RE: PROPOSED WINDFARM AT RAF HARRINGTON.

Oil and Pipeline Agency: turbine 2 and community concern

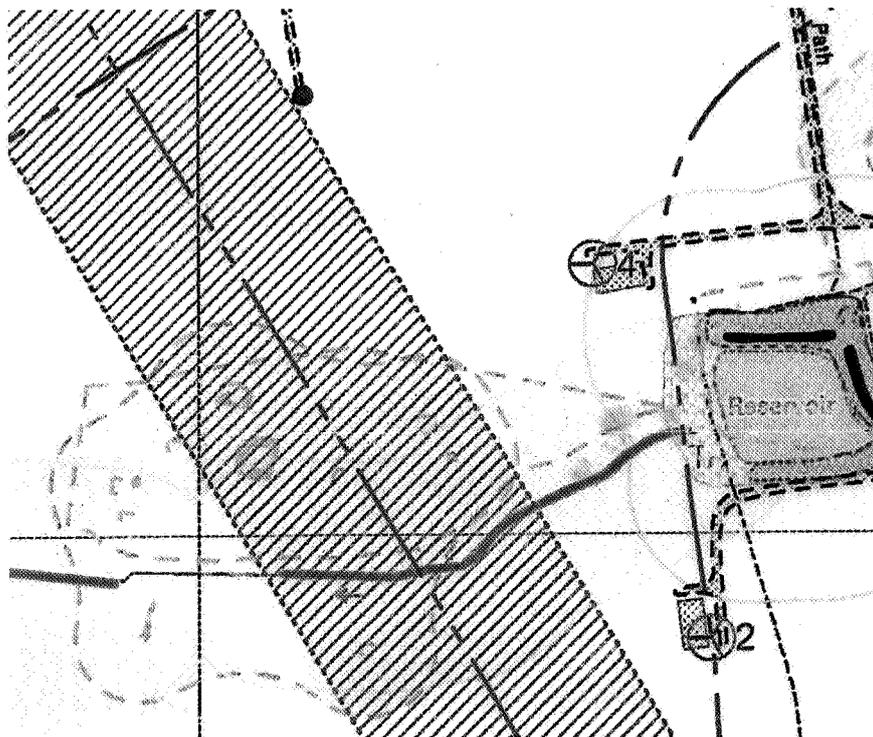
A high pressure military oil pipeline crosses land to the north of Maidwell village and the proposed wind farm. Investigations have revealed that it carries aviation fuel at high pressure (725psi, 15 times atmospheric). The pipeline is part of the Government Pipelines and Storage System (GPSS) and is covered by the Land Powers (Defence) Act of 1958. The only statutory requirement comes from Section 16 of that Act in which it maintains a way-leave of 10 feet around the pipeline itself. We believe that the pipe is of steel and is buried at a depth of circa 1m. Concern to maintain the integrity of the pipeline is such that its entire route is over-flown by helicopter at weekly intervals.

Figure 4.4 of the ES submitted by Nuon, a section of which is shown below, shows the path of the pipeline as a blue line that is buffered (blue cross hatch) at a separation distance of 110m. Turbine 2 is some 10-15m higher up the hill at a distance of around 180m from the buried pipeline and Turbine 4 is 5-10m above the pipeline and at a distance of 250m.
